SUNDRY NOTICES AND REPORTS ON WELLS

CAPROCK MALJAMAR UNIT #250**105' FSL & 991' FEL, UL P, Sec 28, T17S, R33E, Lea County, New Mexico**

API # 30-025-33245
 OGRID # 329487
 BXP Operating, LLC
BEFORE

Operator: BXP Operating, LLC P.O. Box 7227 Dallas, TX 75209	OGRID: 329487
	Action Number: 77315
	Action Type: [C-103] NOI Plug & Abandon (C-103F)

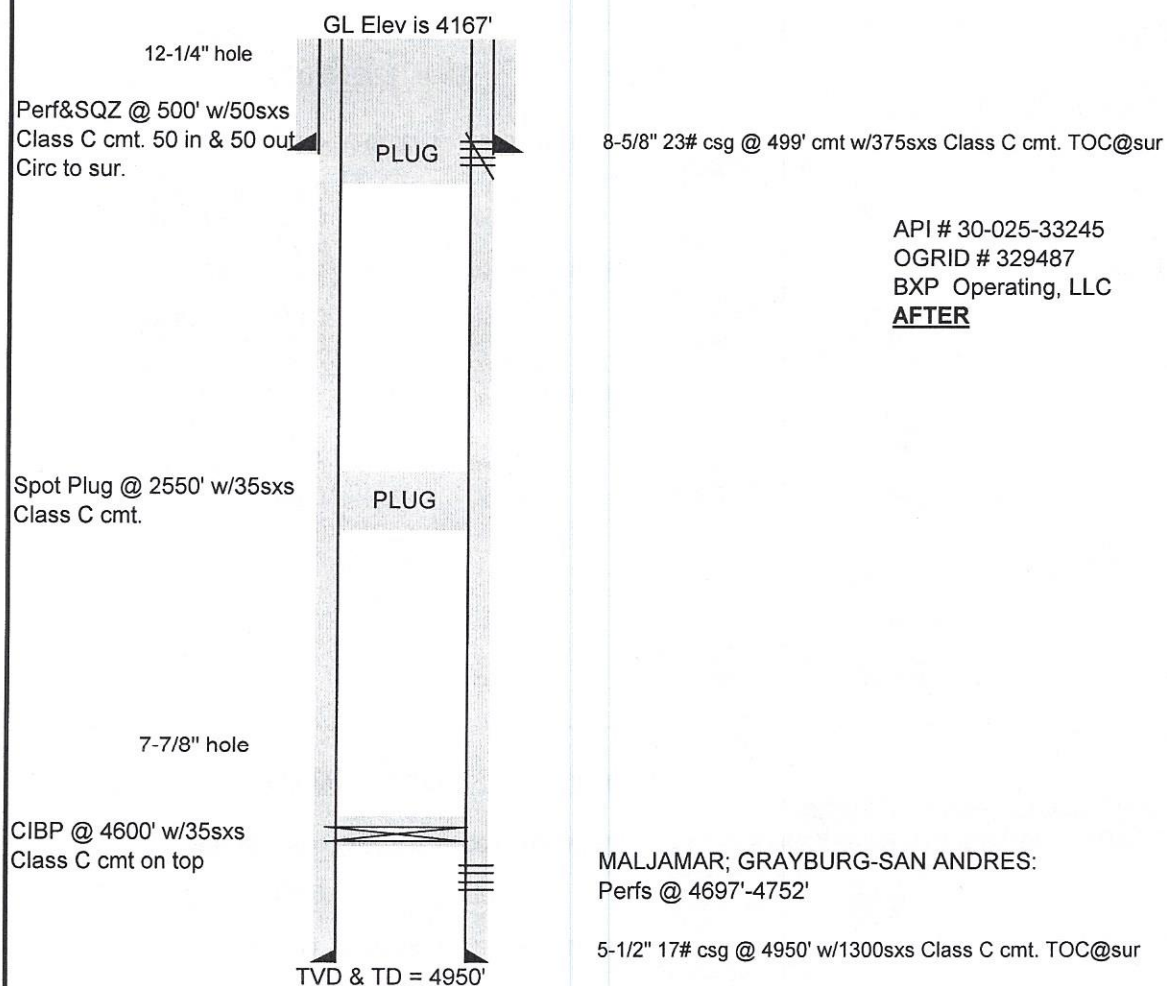
Note changes to procedure
